Bid Addendum No. 4

Valley Central School District 2023 Capital Project – Phase 1

CSArch Project No. 187-2302.01

1 AREA C - PARTIAL FIRST FLOOR FINISH PLAN
AF111 1/4" = 1'-0"

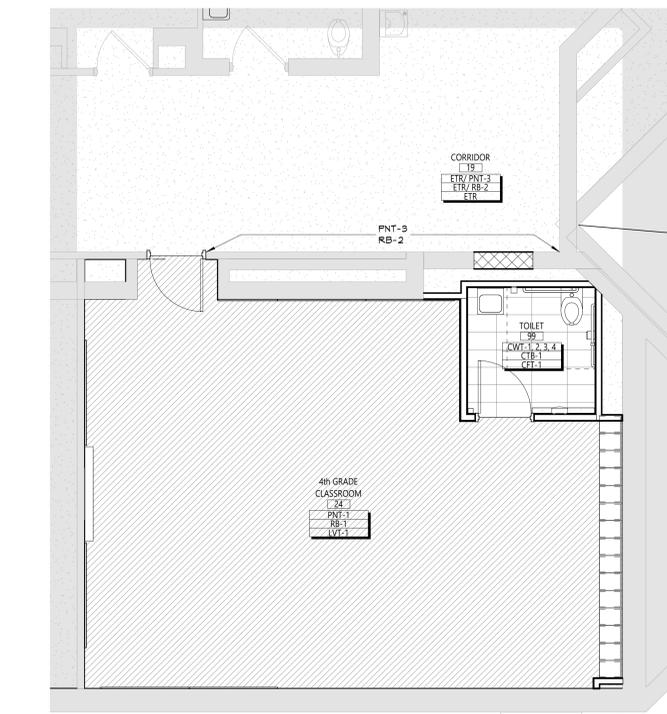
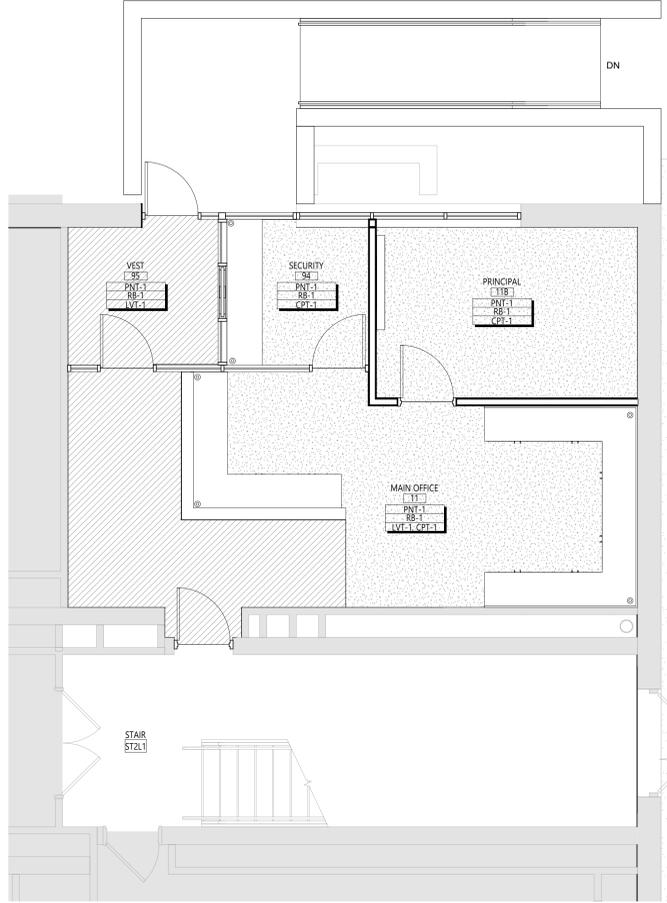
6. On Sheet WES AF111 for the Main Office (Room 11), two floor finishes (LVT-1 and CPT-1) are specified. However, only LVT-1 is represented in the hatch pattern on the drawing. Could you please confirm if CPT-1 is required in the floor finish?

- a. *Response: Refer to revisions to floor finishes in Bid Addendum #4.*
 7. Addendum #3 Specification Section 028213- C Summary of Work Table 5 shows VCHS AA300 as 50 sq/ft of estimated removal, when you refer to Drawing VCHS AA300 Legend shows 625 sq/ft but does not show where this occurs. Please clarify what sq/ft is required to be removed and where this occurs.
